AS- CONSTRUCTED GRADING AND DRAINAGE PLAN  
QUALITY SUITES  
1509 GIBSON BOULEVARD, S.E.  
ALBUQUERQUE, NEW MEXICO

GRADING AND DRAINAGE PLAN  
QUALITY SUITES  
1509 GIBSON BLVD. SE  
ALBUQUERQUE, NEW MEXICO

R  
AUG 19 1997  
HYDROLOGY SECTION

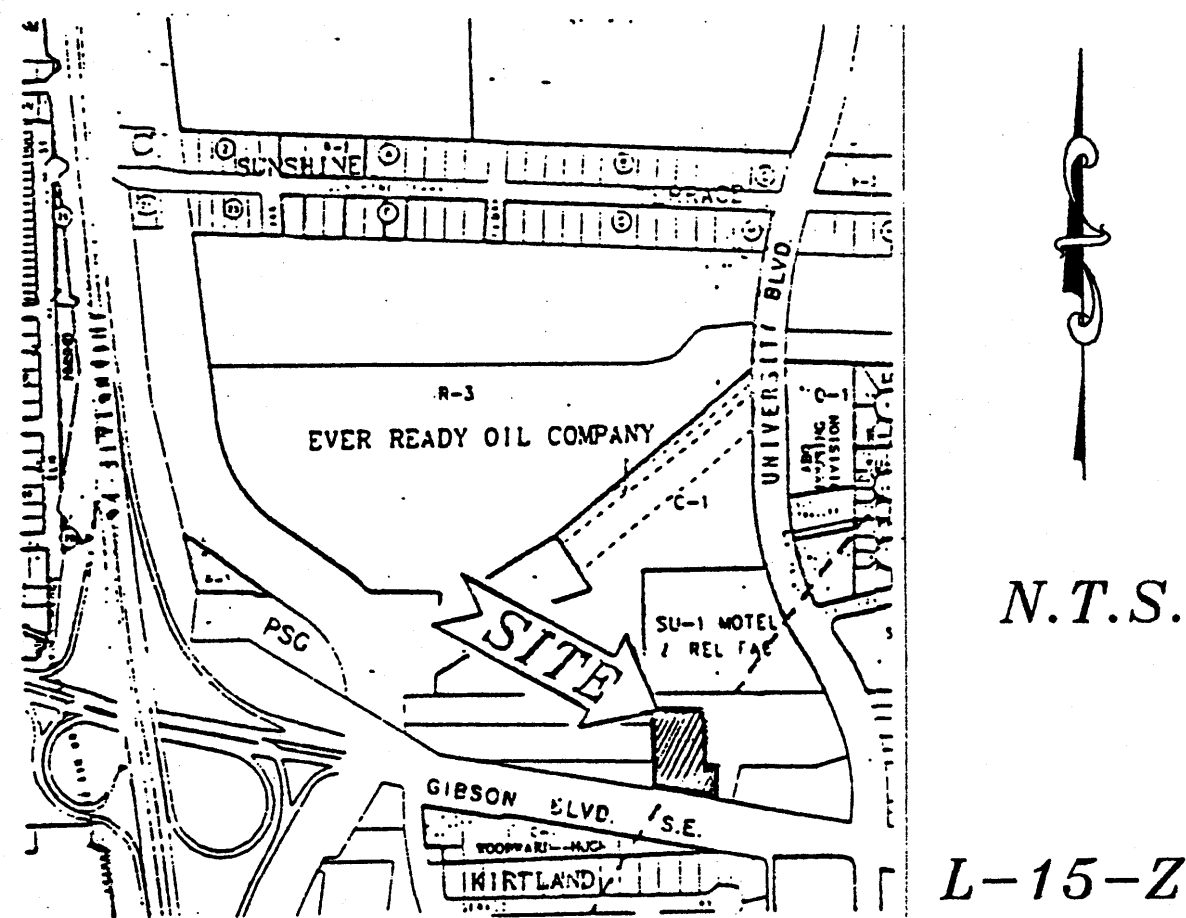
1. Foremost for the 4" PVC pipe accurate  
2. Plot showing all the accurate  
3. Do you have any decision for the area shown in place to allow access from your 5th corner parking lot to the 40 access road on Tract 1  
4. Why do you have five ft wall along the west wall?
